VALUE ENGINEERING REPORT

SR-47 Bridge Replacement Over Little River
BRST0-0076-01(036), PI No. 232310
Columbia/Lincoln Counties

August 27, 2010

BRST0-0076-01(036), P.I. No. 232310
SR 47 Bridge Replacement Over Little River
August 9-12, 2010

Idea No.: A-9B Sheet 2 of 4
 Current 40-foot wide bridge & wider embankment on new alignment to accommodate higher profile

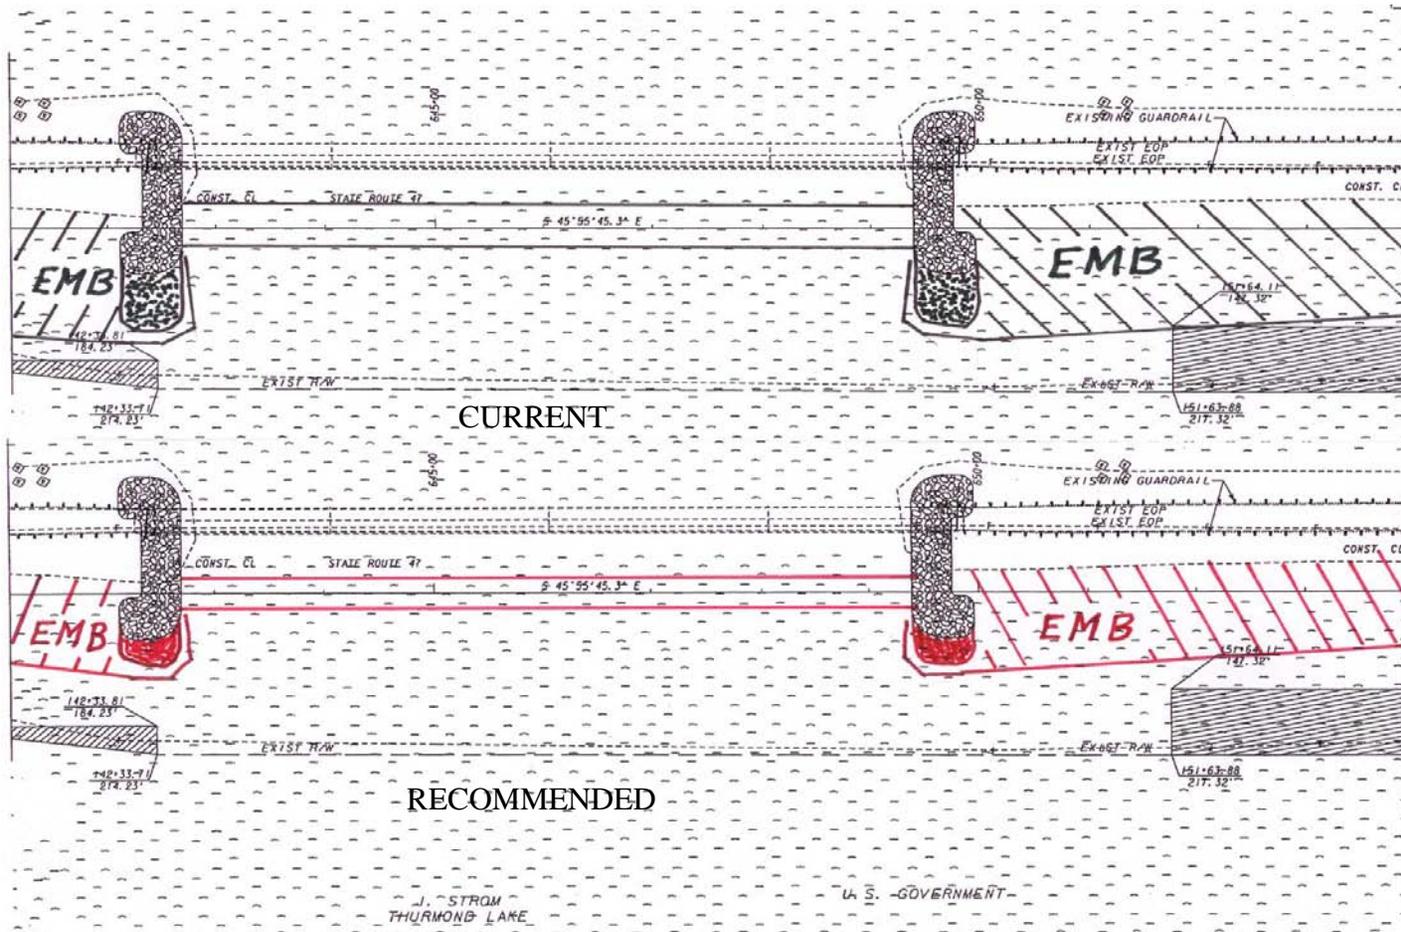
Original Concept: The most recent design shifts the new centerline out about 40 feet west of the original realignment. This realignment widens the west side of the existing causeway to accommodate shifting the causeway away from the existing roadway so the new bridge can be constructed “in the clear.” The new bridge will also be raised to provide 29 feet of clearance under the bridge. This project requires a large amount of new rock embankment to be placed in the lake. This construction will require mitigation measures for open water impacts.

Proposed Change: This recommendation would reduce the width of the shoulders on the bridge from 8 feet to 4 feet thereby narrowing the overall size of the structure.

Justification: The AASHTO guidelines allow for narrower shoulders on long causeways, bridges, and the associated approach roadways. This project is an excellent candidate to apply the AASHTO narrow shoulder guideline due to the unique circumstances of constructing an elevated bridge and its causeway approach roadways within a deep lake. The lake in which the new roadway approaches and bridge will be constructed varies between 40 feet and 60 feet in depth adding to the difficulty of constructing the bridge and the rock embankment.

The VE narrower bridge design would eliminate 8 feet of bridge deck width (at the highest elevation point) along the causeway approaches significantly reducing the amount of rock embankment to be placed in the lake. The VE concept reduces the project’s impact on the lake, reduces State construction risk tied to constructing a project in a deep lake, reduces the amount of rock and roadway embankment, simplifies and accelerates construction operations, and reduces cost. The VE team assumed the 8-foot reduction in rock embankment would occur only for the length (500 ft on either side) of the new elevated roadway section.

VE 32-foot wide bridge & narrower embankment on new alignment to accommodate higher profile

Sheet 3 of 5

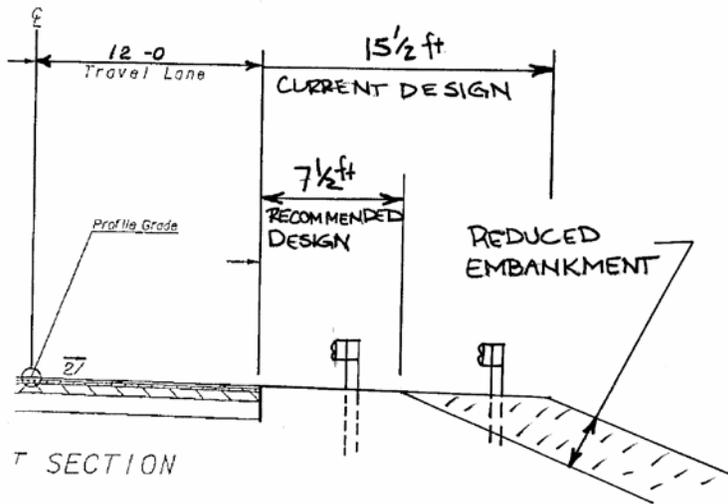
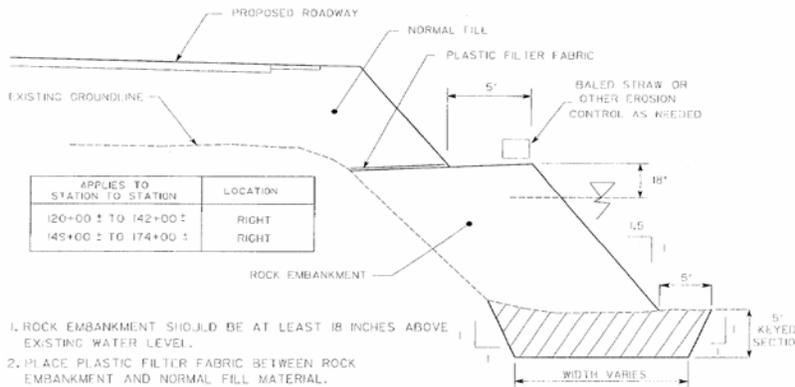
Original Concept: The current design for the causeway approaches to the new bridge includes a 10-foot paved shoulder. The causeway approaches will require guardrail throughout the entire approach section. Installing guardrail will extend the paved shoulder out to 15.5 feet resulting in a 55-foot total roadway width. The higher/wider new roadway section will require adding significant amounts of new rock embankment into the lake. This project will require mitigation measures for open water impacts.

Proposed Change: This recommendation would reduce the shoulder width on the causeway approach sections from 10 feet to 4 feet. Adding guardrail to this section would add another 3.5 feet resulting in a total shoulder width of 7.5 feet resulting in a 39-foot total roadway width.

Justification: The purpose of this project is to replace an old truss bridge with a sufficiency rating of 49.79. The existing causeway approach sections are 36 feet wide. The current design for the roadway section consists of 24 feet of pavement with 15.5 feet of paved shoulder/guardrail area resulting in a total width of 55 feet. The VE concept would reduce the total roadway width from 55 feet to 39 feet. This concept would eliminate a 16-foot width of new rock embankment from being placed into the lake. Based on the current alignment and costs, the rock embankment construction is about 70% of the overall roadway construction. This figure will be even higher with the new elevated profile. Reducing the rock embankment will provide the most savings.

Idea No.: A-10
 Client: GDOT
 Sheet 3 of 5

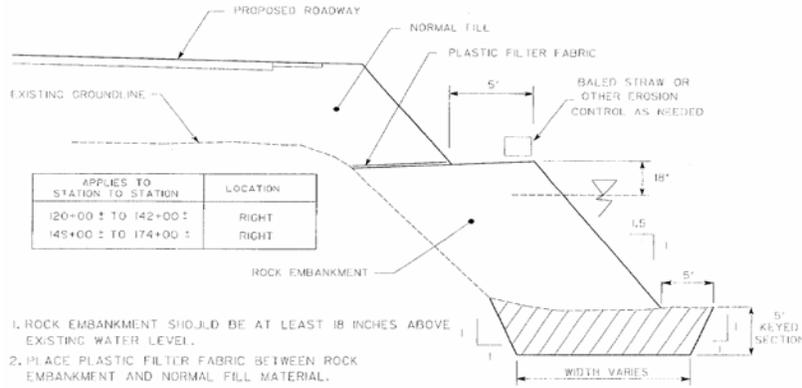
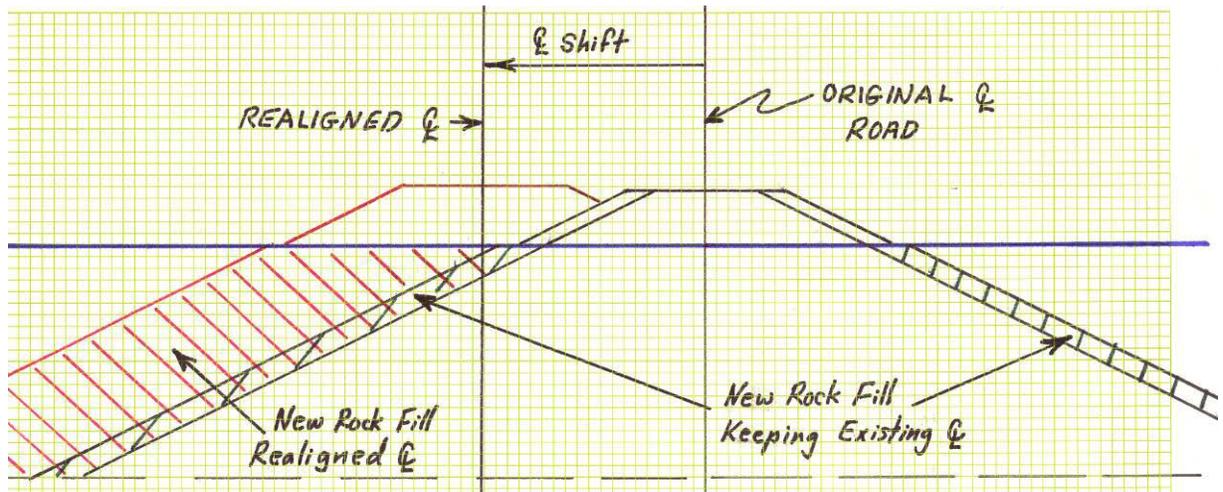
Original Concept: The most recent design shifts the new centerline out approximately 40 feet west of the original realignment and maintains 2-way traffic on the existing road while constructing the new bridge and roadway approaches. This realignment widens the west side of the existing causeway to accommodate shifting approximately 2,000 feet of the north causeway and 2,000 feet of the south causeway away from the existing roadway so the new bridge can be constructed “in the clear.”

Proposed Change: This recommendation would construct the new bridge and causeway approaches centered on the existing alignment and detour traffic around the project.

Justification: This project will replace the 740-foot truss bridge and causeway approaches in the center of Strom Thurmond Lake. The new bridge and 4,000 feet of realigned new causeway will be constructed within the lake. This construction will be in water that is 40 feet to over 60 feet deep adding to the complexity of the project and increasing the project’s negative impact on the lake. The new rock embankment near the bridge abutments will be larger than originally designed because the profile has been raised an additional 18 feet.

The VE concept of reconstructing on the existing roadway alignment will significantly reduce the amount of new rock embankment that has to be placed in the lake. Instead of having to construct a wide new embankment for the realigned roadway, the VE concept would only require the construction of small amounts of new embankment on both sides of the existing causeway to accommodate the wider new roadway.

Sheet 3 of 5

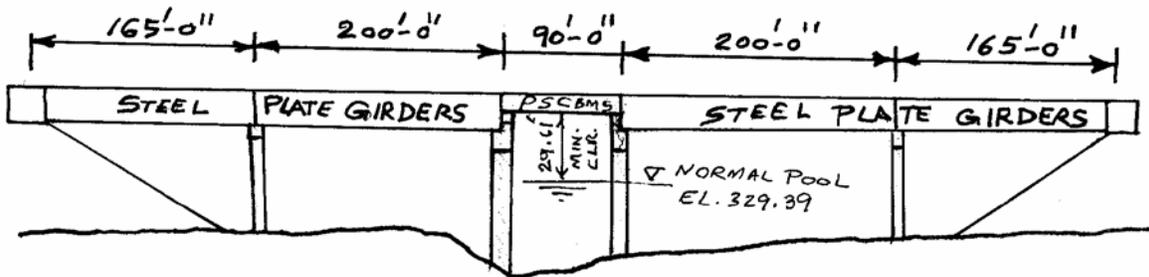
Original Concept: The preliminary bridge design consists of two alternate designs:

This recommendation would construct a 90-foot center span using Type 3 AASHTO PSC beams and construct the remaining sides of the bridge using longer two-span continuous steel plate girders (165'-200'). This results in a total structure length of 820 feet. The recreational watercrafts can pass through 90 feet center span with minimum available vertical clearance of 29 feet.

The VE concept provides for the required 29-foot vertical opening through the center portion of the structure while minimizing the height of the roadway profile. The new span arrangement will allow for lowering the profile of the roadway by 3 feet. This concept results in a reduction in the amount of rock and roadway embankment along the entire length of the project.

The 90-foot span was chosen as the adequate span for a Type III beam and a reasonable width for boats to pass underneath. A slightly narrower span should also suffice. Establishing the minimum width for the opening is a key design element. This should be coordinated with COE and/or the local navigational codes.

Idea No.: D-2
 Client: GDOT
 Sheet 2 of 4

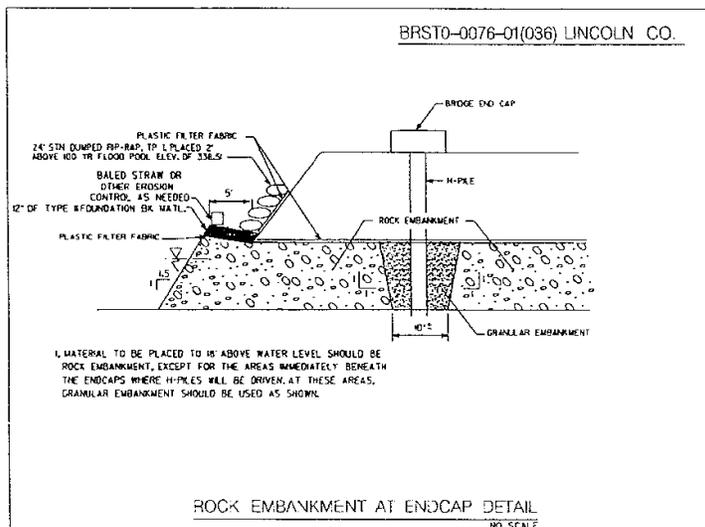
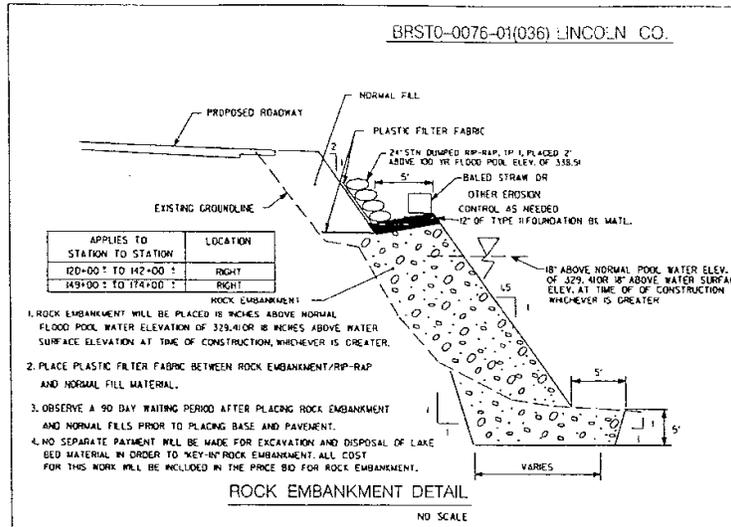
The original design includes the placement of a 12-inch layer of Type II Foundation Backfill Material on the top (bench area) of the rock embankment.

This recommendation eliminates the placement of the Type II Foundation Backfill Material on top of the rock embankment.

The rock embankment is being placed to an elevation that is 18 inches above the normal flood pool elevation. The roadway fill material will be placed on top of plastic filter fabric over the rock embankment to within 5 feet of the edge of the rock embankment. Since the roadway embankment will be protected by riprap to an elevation above the 100-year flood, there is no need to place the 12-inch layer of Type II backfill material.

Idea No.: F-3
Client: GDOT
Sheet 2 of 6

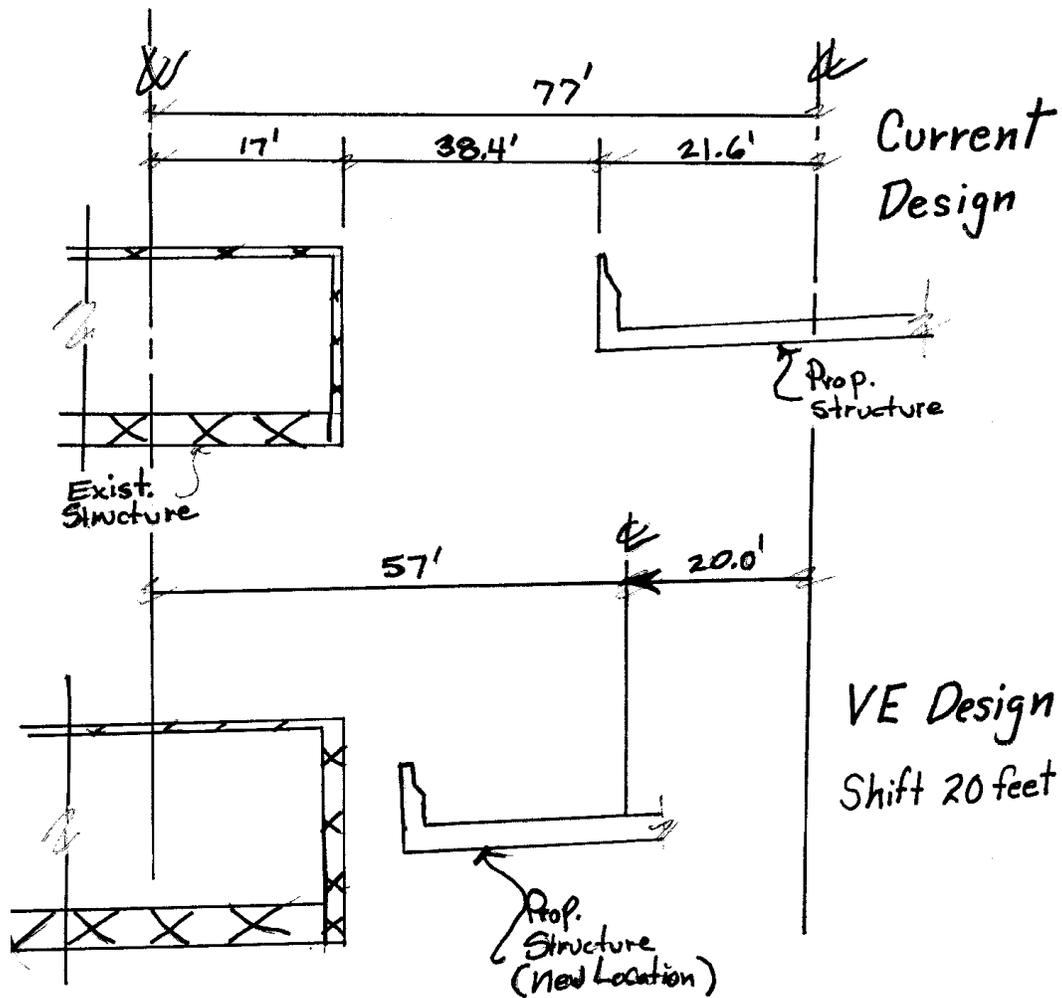
The new alignment to accommodate the additional vertical clearance (18 feet, 29 feet total) required by the COE shifted the centerline approximately 40 feet out from the original alignment. This 40-foot outward shift will require significant additional rock and roadway embankment.

This recommendation would construct the new roadway embankment 20 feet closer to the existing roadway by using sheet piling to hold up the inside portion of the new embankment while it is being constructed.

This 20-foot shift would reduce the amount of rock and roadway embankment. Reducing the quantities for these items would make the embankments easier to construct, accelerate construction, and reduce the project cost. Reducing the revised elevated alignment shift by 20 feet (at the center of the bridge) will still provide adequate clearance to construct the new bridge in a single stage. This concept also allows existing traffic to be maintained throughout the construction of the project.

Idea No.: F-5
 Client: GDOT
 Sheet 2 of 4

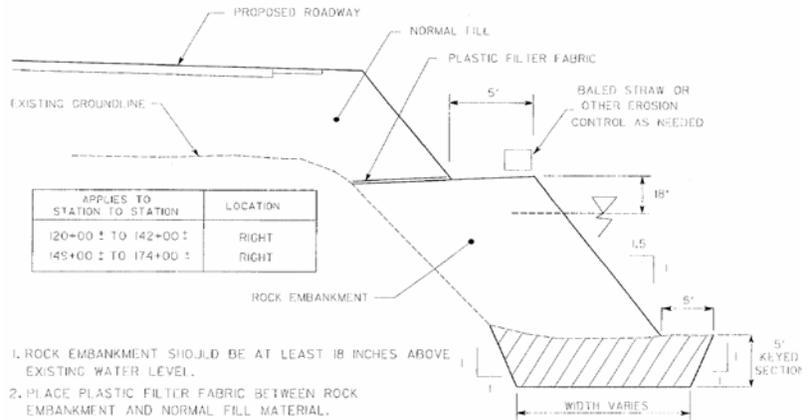
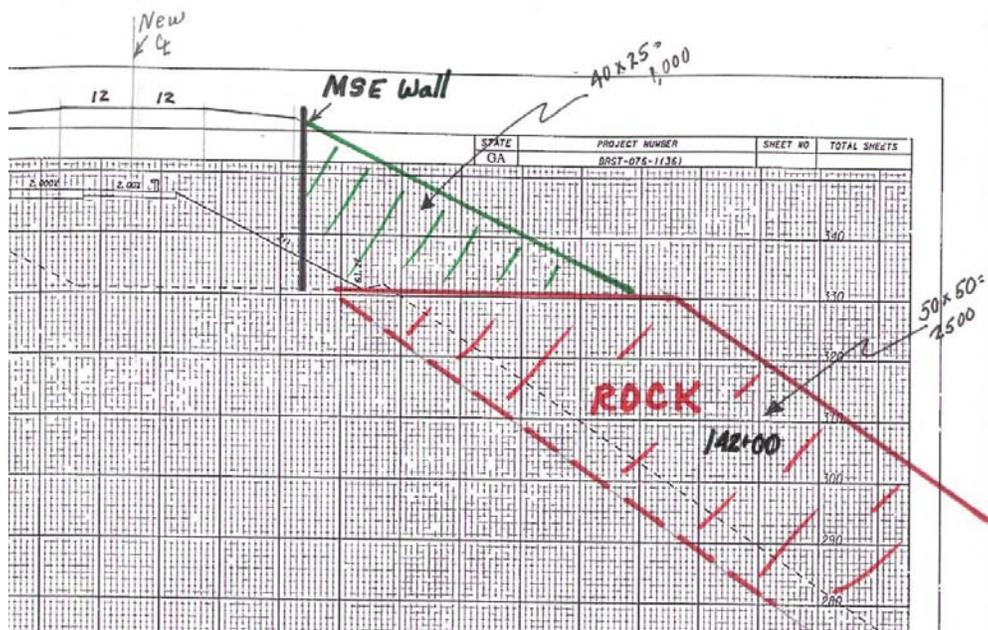
Proposed Change: This recommendation would construct an MSE wall on the outside edge of the new roadway and construct the new roadway embankment between the MSE wall and the existing roadway embankment. This concept assumes the revised (8/9/2010) alignment for the elevated bridge.

Justification: Constructing the new approach roadway between an MSE wall and the existing roadway embankment will reduce the width of the new roadway and rock embankment. This concept eliminates most of the additional rock embankment that would be required to construct the revised (shifted out) alignment for the elevated bridge.
